FINAL DRAFT MINUTES

January 20, 2022 Standards Committee Meeting

RE: Minutes from the January 20, 2022 Standards Committee Meeting

INDIANA DEPARTMENT OF TRANSPORTATION	
DYNAMIC MESSAGE SIGN STRUCTURE END SUPPORT BASE PLATE AND I.D. TAG DETAILS	
SEPTEMBER 2013	
STANDARD DRAWING NO. E 802-DMSS-10	
	/s/ Alfredo B. Hanza 02/05/13 DESIGN STANDARDS ENGINEER DATE
	/s/ Mark A. Miller 03/27/13 CHIEF ENGINEER DATE

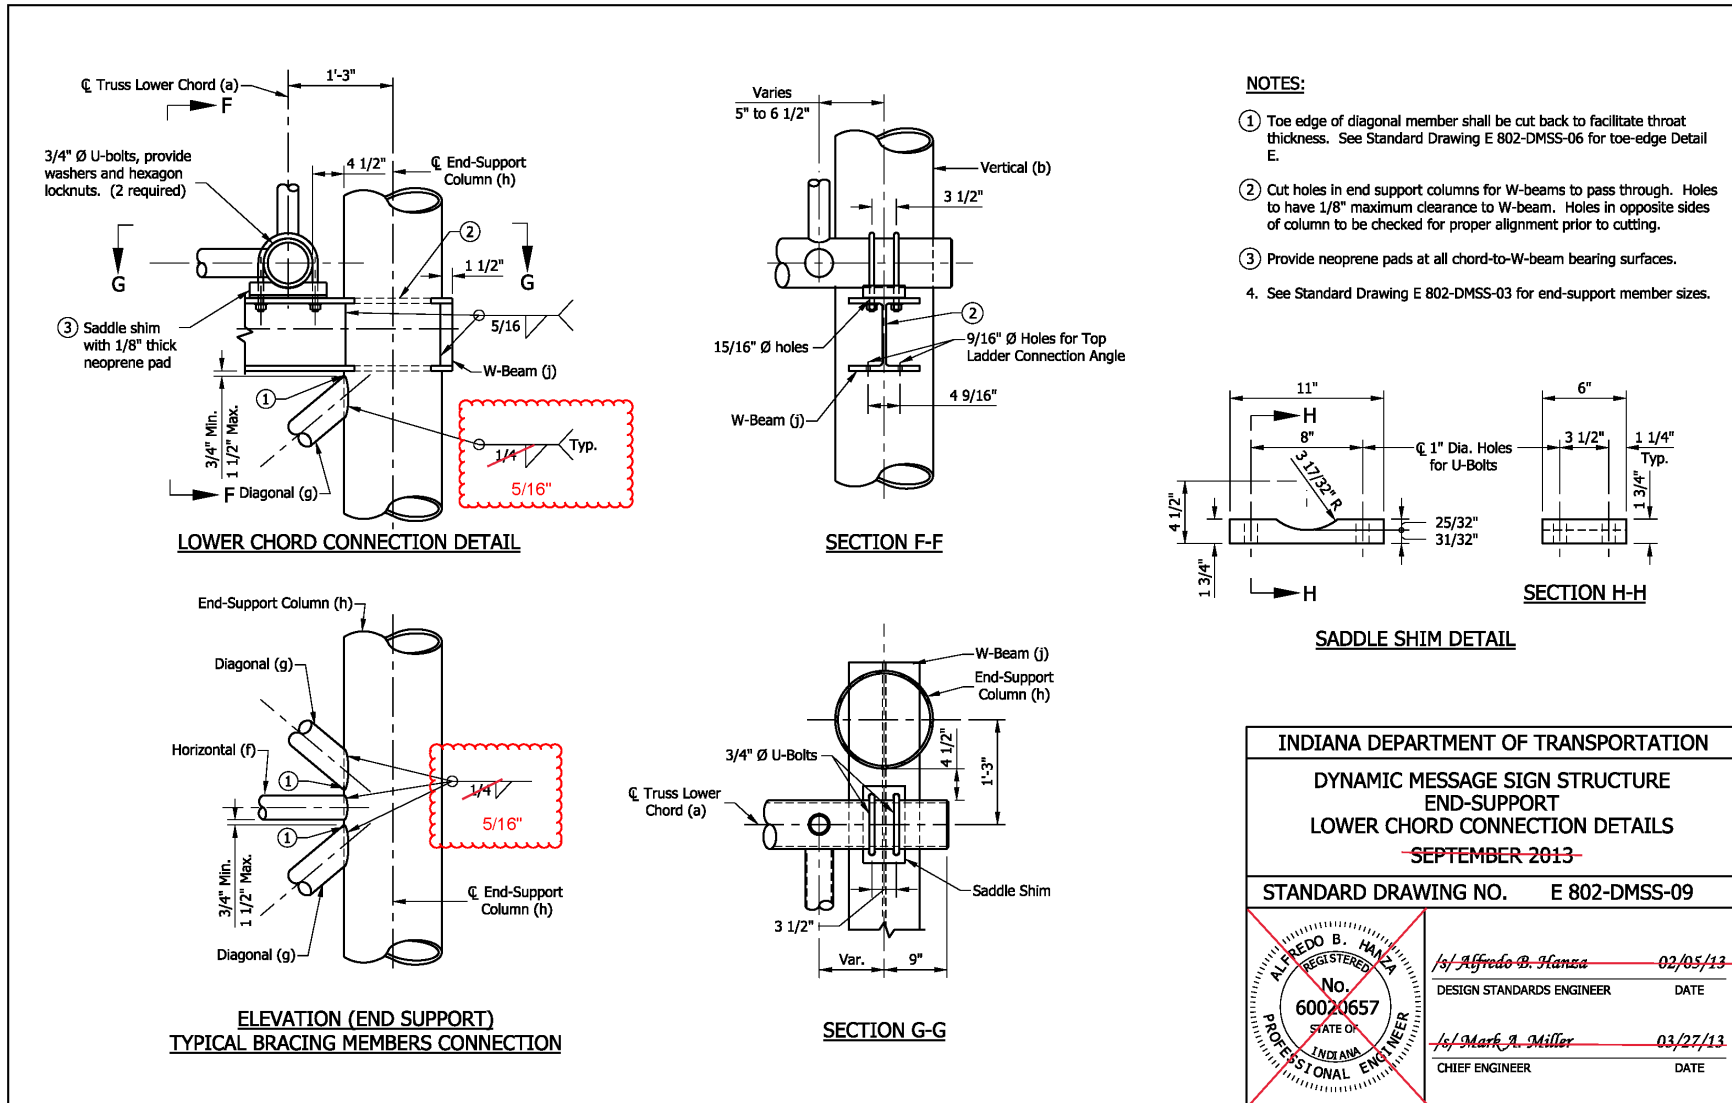
I.D. PLATE AND OTHER DETAILS
 ADDED TO SHEET

- ① See Standard Drawing E 802-DMSS-11 for handhole details.
2. See Standard Drawing E 802-DMSS-12 for anchor bolts and skirt details.
- ③ I.D. tag is a 1/8" stainless steel plate with the following information stamped in 1/2" black letters:
~~Manufacturer _____, Drawing/Order # _____~~
~~Contract # _____, Structure Type _____~~
~~Fabrication Date _____, Structure Length _____~~
~~End Support Mounting Height _____~~
4. Each end support requires one I.D. tag.

STANDARD DRAWING NO. E 802-DMSS-17

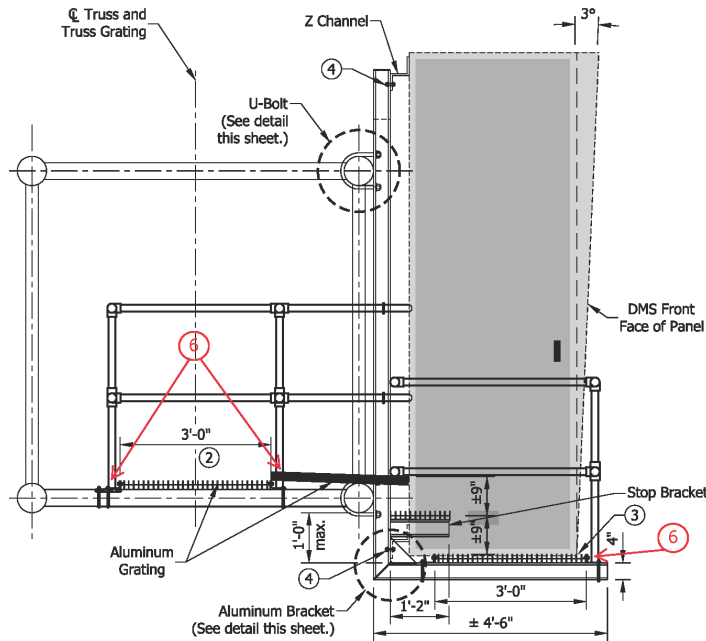
TYPICAL HANDRAIL DETAIL NEW DETAILS ADDED

6. See Typical Drain Hole Detail

PROPOSED SOLUTION: Design the structures per latest AASHTO LRFD 2015 code, revise the standard drawings accordingly. Add detail on the proper anchor bolt hardware tightening order ("star pattern"). Add a detail for drain holes in the handrail post (DMSS series).
